Daniel J. Evans, CHP
8 White Oak Road
Ansonia, CT. 06401
July 23, 2015

Subject:
Voidance of License Application Request, PLUS, LLC
Application Dated October 1, 2014

Reference Docket No. 030-38784

PLUS, LLC Distribution License Application Clarification

BLUEPRINT OF THE PRODUCT

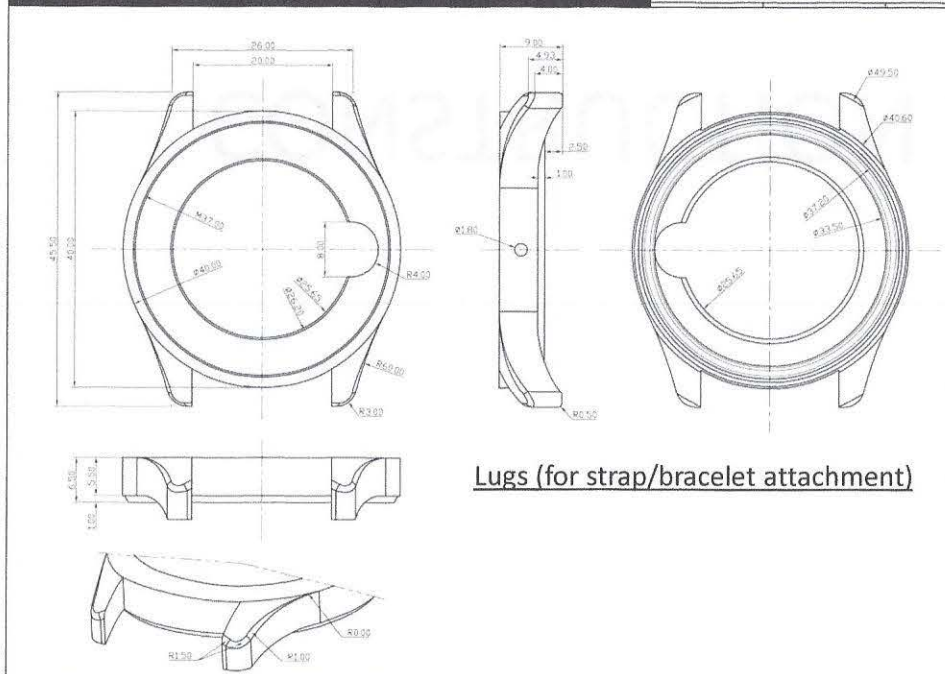
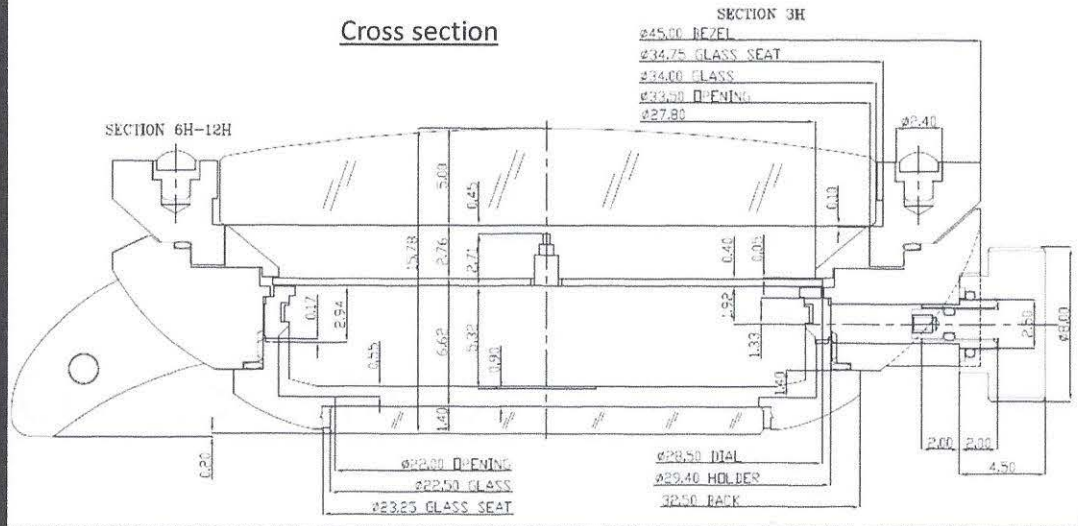
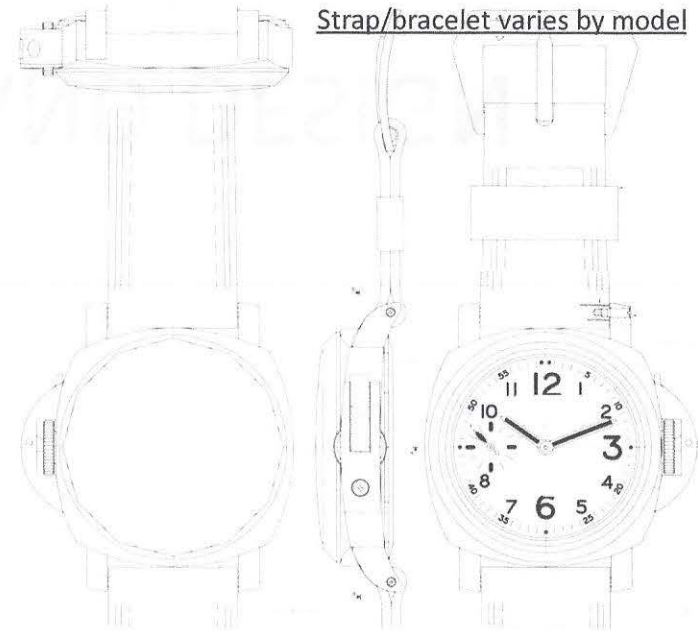
Submit the details of construction and design of each individual model of the watches that you plan to distribute. These include any associated diagrams and/or blueprints of each watch model.

The outer structure of all the watch models is the same. Differences in models are due to variations in superficial aspects such as color, patterns, material of case or bracelet. These variations are described in the detailed overview of each model in subsequent slides. Also, the internal structure within each watch may differ between models, hence the blueprints for these have been attached separately in this section along with each model grouping in subsequent slides.

The basic components of each product, as indicated in the following illustration, remain consistent.

14 tritium micro-gas tubes in glass housing:
One on each of the 12 hour markers, one on the hour hand, and one on the minute hand

However, there are no changes in the models of the tritium gas-tubes or their positioning or binding across any of the product models. These remain uniform throughout. Within every product model, the tritium gas-tubes used are the following.

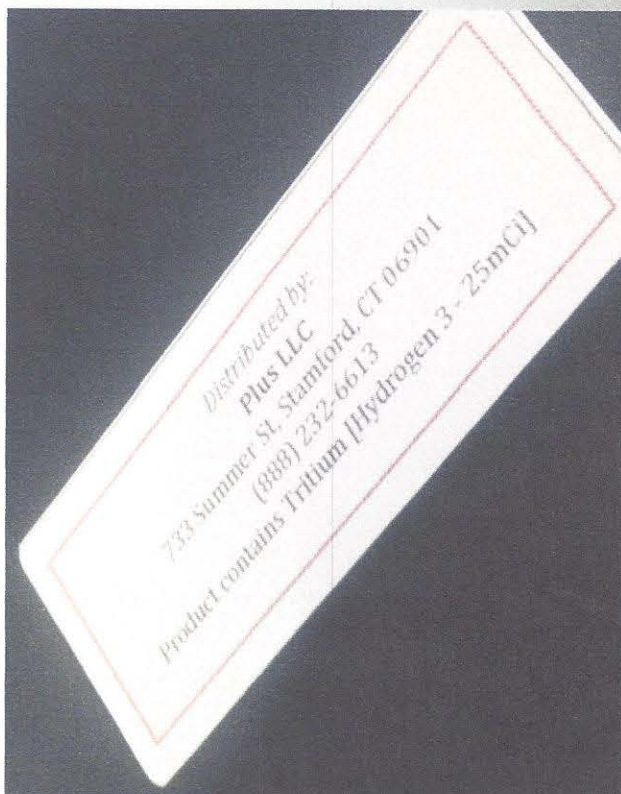
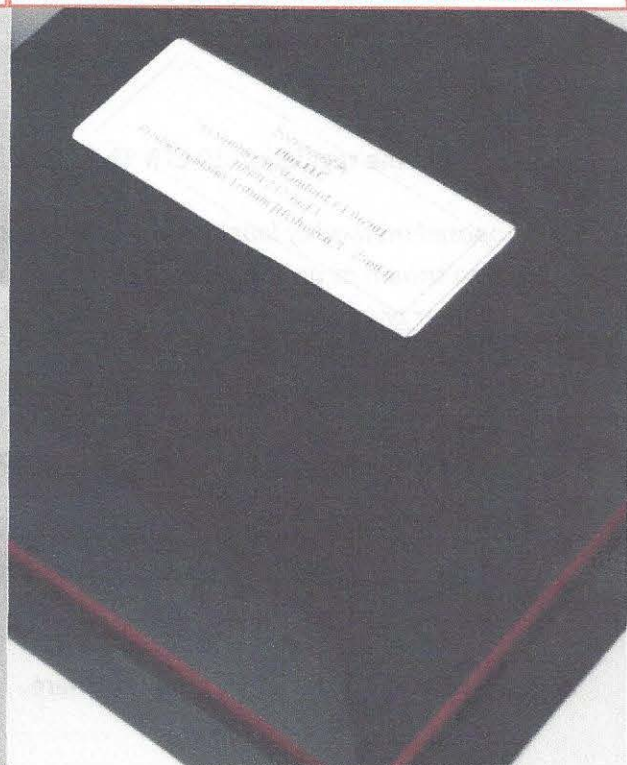
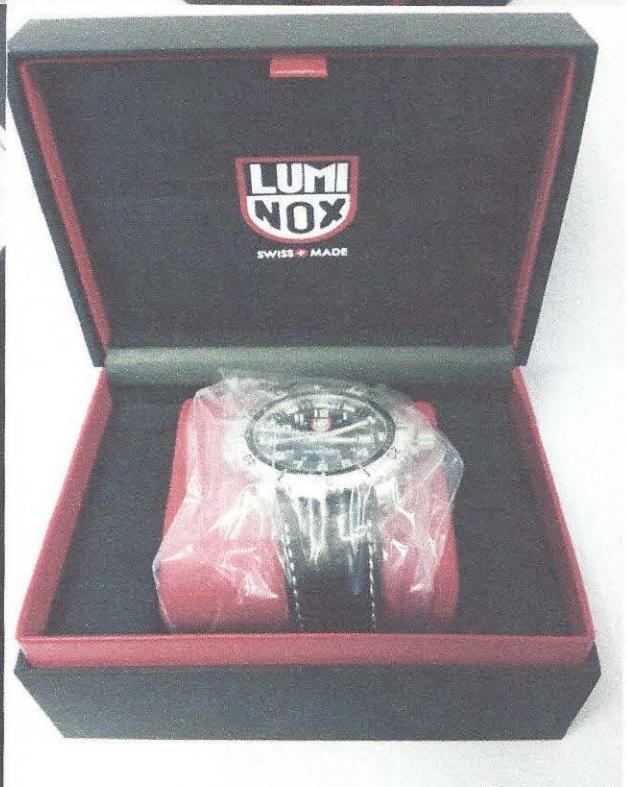
Submit a proposed label for the container (e.g. drawing, imaging) that includes byproduct information).

It is the intention of PLUS, LLC to label each watch delivered to end consumer with:

1. Contact information for PLUS, LLC
2. Isotope (Byproduct Material) included in the package.
3. Total activity of the included isotope.
